STAFF REPORT
Major Subdivision

Docket No. ES-116-20
Summary No.

Subdivision: Colonial Farms Subdivision	Council District: 2
Location: 142 Sauve Rd.; bounded by Jefferson Hwy., Manguno Dr., & Sauve Oaks Ln. (Figure 1)	PAB Hearing: 03/24/2022 Deferred to 4/28/22
Owner: Investment Holdings LLC	Last Meeting Date for Council Action: 07/27/2022
Applicant: Tim Madden

Subdivision of Lot 4-G, Colonial Farms Subdivision into Lots 4G1, 4G2, 4G3, 4G4, 4G5, 4G6, 4G7, & a 26-ft. roadway, and the dedication of a 12-ft. servitude as a preliminary/final plat with a development agreement; Colonial Farms Subdivision, with waivers to the area regulations of the proposed R-2 district, to lot arrangement standards, and to lot orientation standards.

FIGURE 2

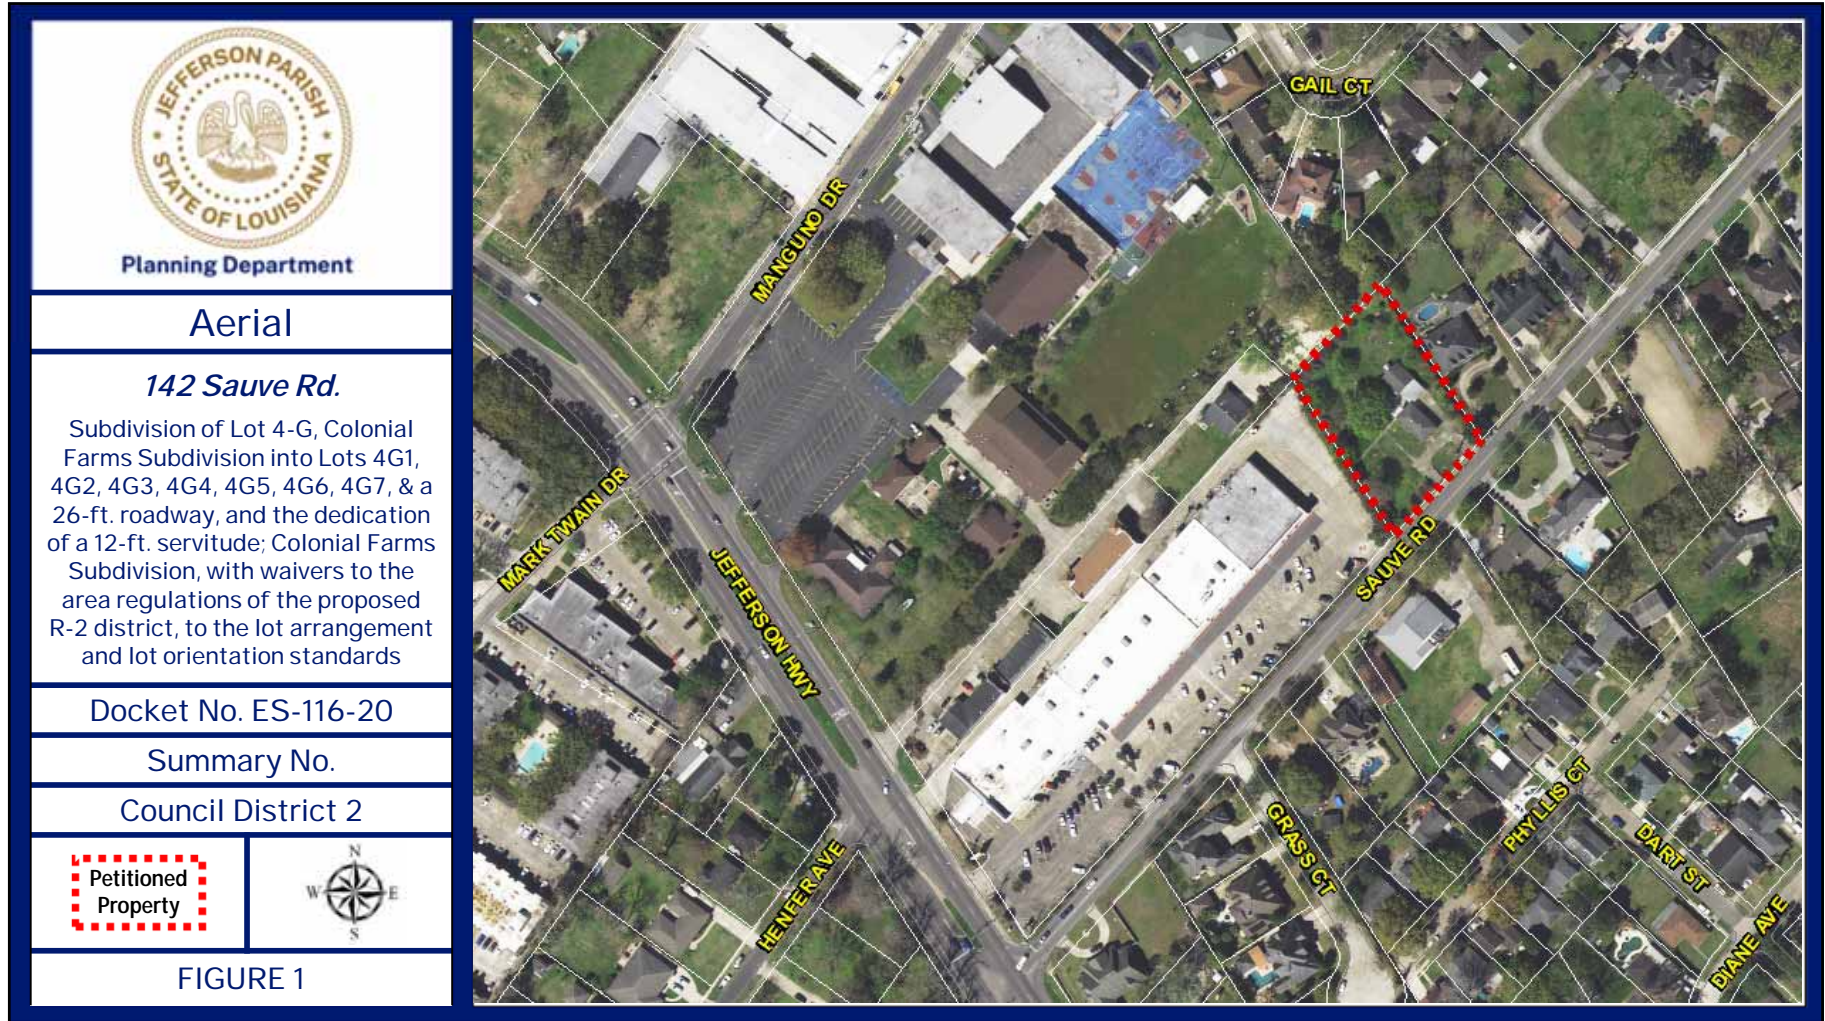
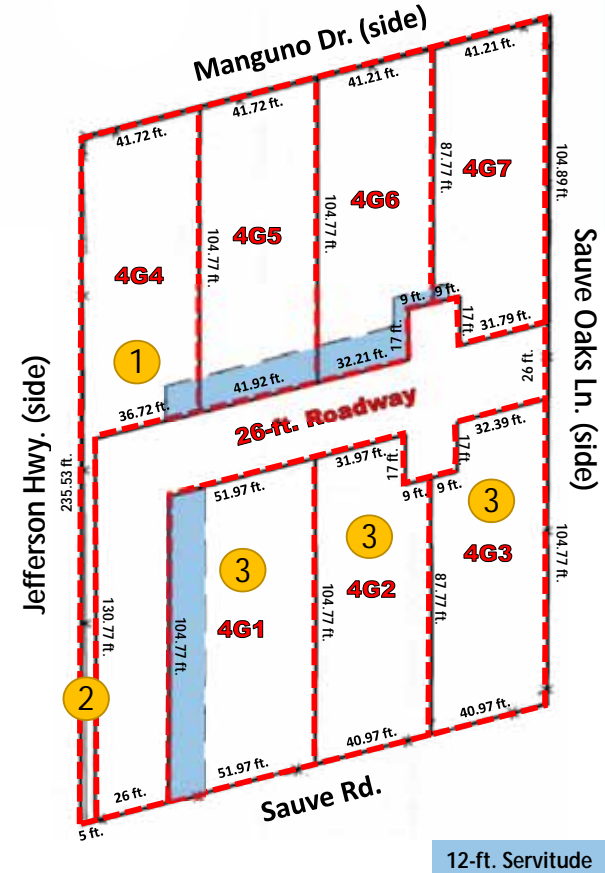
1. The purpose of this requested subdivision is to create seven lots of record and a 26-ft. substandard roadway from one existing lot of record. The proposal also includes the dedication of a 12-ft. servitude (Figure 2).

- A five-ft. strip is proposed along the left side of Proposed Lot 4G4 from the rear of the lot all the way to Sauve Rd. Due to the 5-ft. strip, Proposed Lot 4G4 is deficient in 40-ft. width requirement for single-family dwellings in the proposed R-2 district,

as the strip is included in the calculation of the lot's average width. As such, the average width of Proposed Lot 4G4 is 23.36 ft. necessitating a waiver of 16.64 ft.

- Per Sec. 33-6.6.2.f, through lots shall be prohibited in residentially zoned areas, except when the rear of the lot abuts an arterial street and no access to that street is allowed. Proposed Lots 4G1, 4G2, and 4G3 are oriented as through lots in a residential district with frontage on both the proposed 26-ft. roadway and on Sauve Rd., which is classified as a collector street. As such, these proposed lots do not meet the exception found in Sec. 33-6.6.2.f and a lot orientation waiver is required.

12. There are unresolved issues in the LURTC review:
 - Public Works is opposed in LURTC to the proposed subdivision. Public Works is requiring a revised subdivision plat showing the text added "26' private driveway, access and utility servitude in favor of lots 4G4, 4G5, 4G6, 4G7" with leader lines.

- Planning has requested clarification to the purpose of Proposed Lot 4G4's five-ft. strip, and has required additional language be added to the plat specifically stating that "Access will be blocked from Sauve Rd. for Lots 4G1, 4G2, and 4G3."
